CONTRACT CHANGE ORDER No. 170

ROADWAY LEVEL WESTBOUND
LIGHTING AND ELECTRICAL SYSTEMS
SCALE: 1:200

EE-30

E-40

CONDUIT PLAN

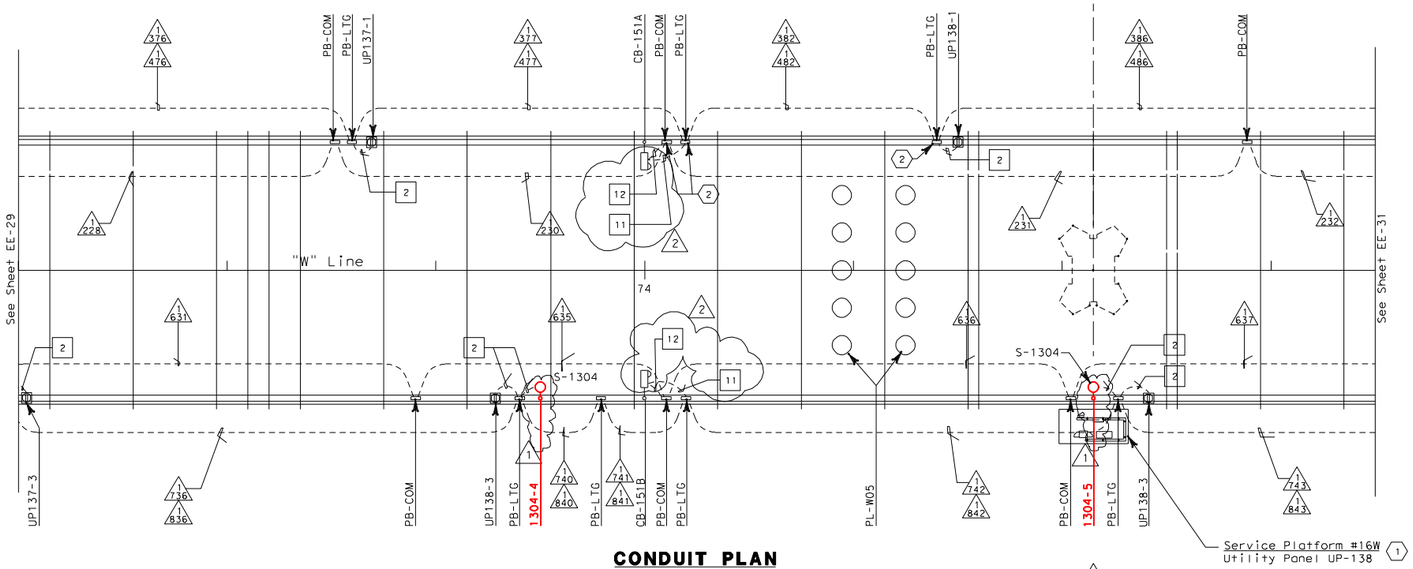
MARK	DATE	DESCRIPTIONS	REV	CK
2	1/20/06	Delete CB-151A & CB-151B. Coil 5 m of call box signal and power cable in adjacent PB-COM and PB-LTG pull boxes.	JE	EJL
1	3/2/05	Delete Roadway light poles and fixtures. Coil 10m, 3#10 conductors in the pull box adjacent to light pole locations.	RS	PB
